APPLICATION NO.	FILING DATE	FIRST NAMED INVENTOR	ATTORNEY DOCKET NO.	CONFIRMATION NO.	
09/970,125	10/03/2001	Gary E. Bement	S01.12-0718/STL 9917-9918	2107	
7590 10/22/2003			EXAMI	NER	
Deirdre Megley Kvale WESTMAN CHAMPLIN & KELLY International Centre - Suite 1600			HEINZ, ALLEN J		
			ART UNIT	PAPER NUMBER	
900 South Second Avenue			2653	77	
Minneapolis, MN 55402-3319			DATE MAILED: 10/22/2003	, 5

Application No.	plicant(s)	
Office Action Summary		09/970,125	BEMENT ET AL.	
		Examiner	Art Unit	<u> </u>
		A. J. HEINZ	2653	
Period fo				idress
THE I - Externanter - If the - If NO - Failu - Any r	ORTENED STATUTORY PERIOD FOR REPL MAILING DATE OF THIS COMMUNICATION. Issions of time may be available under the provisions of 37 CFR 1. SIX (6) MONTHS from the mailing date of this communication. period for reply specified above is less than thirty (30) days, a rep period for reply is specified above, the maximum statutory period re to reply within the set or extended period for reply will, by statute eply received by the Office later than three months after the mailined patent term adjustment. See 37 CFR 1.704(b).	136(a). In no event, however, many minimum of the statutory minimum of will

FIG. 7 126 DRIVE CIRCURITY 100 60 128 122 104 <u>66</u> 108 106 2 Plural flexure elements

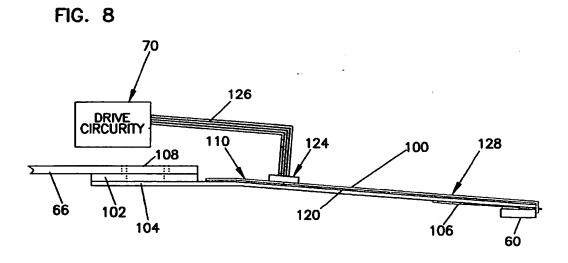
Re claims 5,9,12,14,16; See Fig. 7. Note, to the extent claimed and understood, the structure as shown in Addendum A reads on and performs to the same degree as claimed.
